**PLANNED UNIT DEVELOPMENT &
SUBDIVISION STAFF REPORT****Date: May 6, 2004**

DEVELOPMENT NAME Heron Lakes Subdivision, Phase One, Revised Lot 33

LOCATION 1063 Grand Heron Court West
(North side of Grand Heron Court West, 200'± East of its West terminus)

SITE PLAN

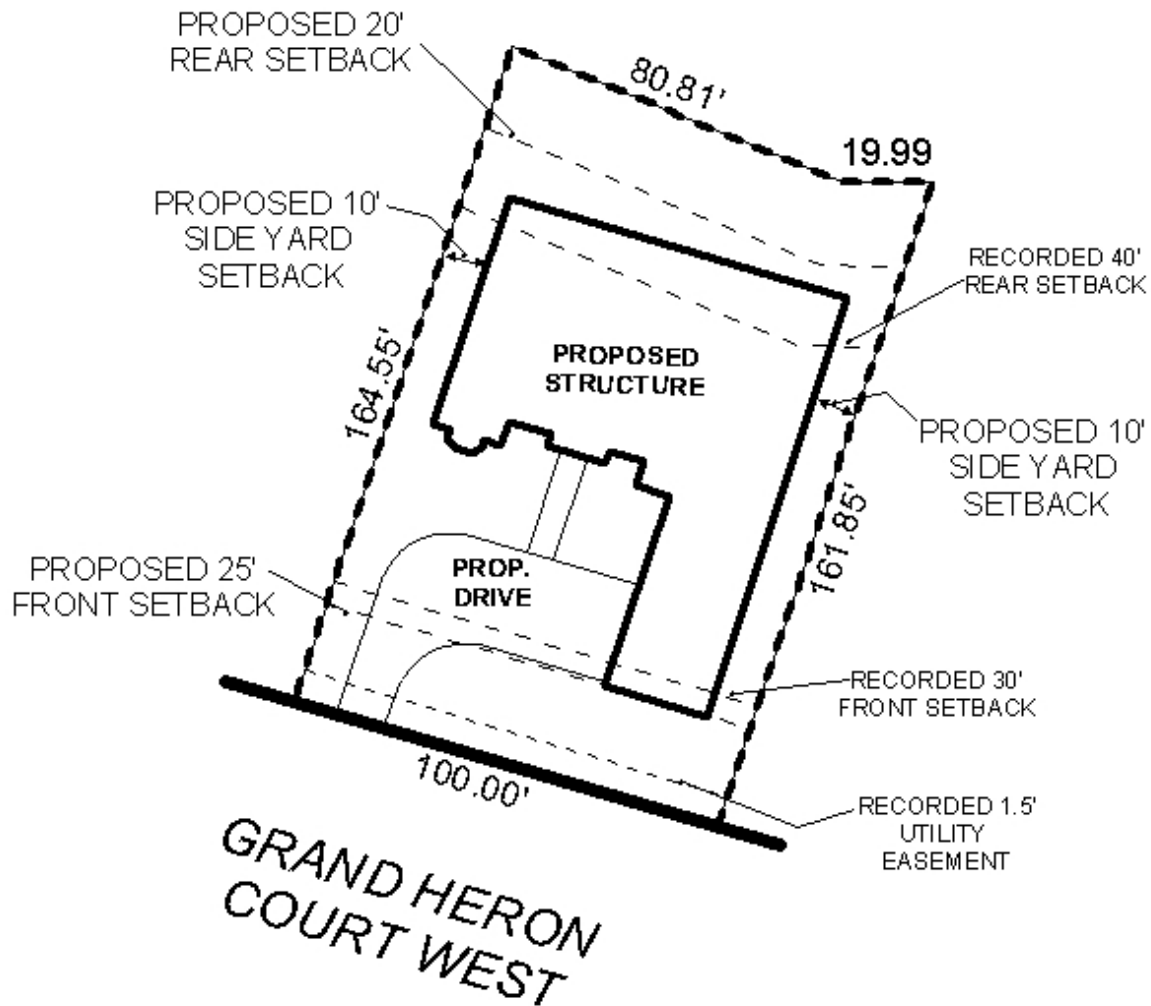
**ENGINEERING
COMMENTS** Engineer to provide verification that existing stormwater system, including designed and constructed detention, can accommodate increased coverage. Must comply with all stormwater and flood control ordinances. Any work performed in the right of way will require a right of way permit.

include paved areas such as driveways and patios. Additionally, the record plat illustrates 40-foot rear yard and 30-foot front yard setbacks; the applicant proposes to reduce the front yard setback to 25-feet and the rear yard setback to 20-feet, thus Subdivision approval is also required to modify these setbacks on the record plat.

The proposed setback lines (25-feet along the front and 20-feet along the rear) comply with the minimum setback requirements of both the Zoning Ordinance and Subdivision Regulations and thus could be considered appropriate for the site. Furthermore, there have been numerous requests for modified front and rear yard setbacks in Heron Lakes.

Planned Unit Development: Based upon the preceding, this application is recommended for approval subject to the following condition: 1) that the Engineer provide verification that the existing stormwater system, including designed and constructed detention, can accommodate the increased site coverage.

Subdivision: The plat meets the minimum requirements of the Subdivision Regulations and is recommended for Tentative Approval subject to the following condition: 1) that the Engineer provide verification that the existing stormwater system, including designed and constructed detention, can accommodate the increased site coverage.
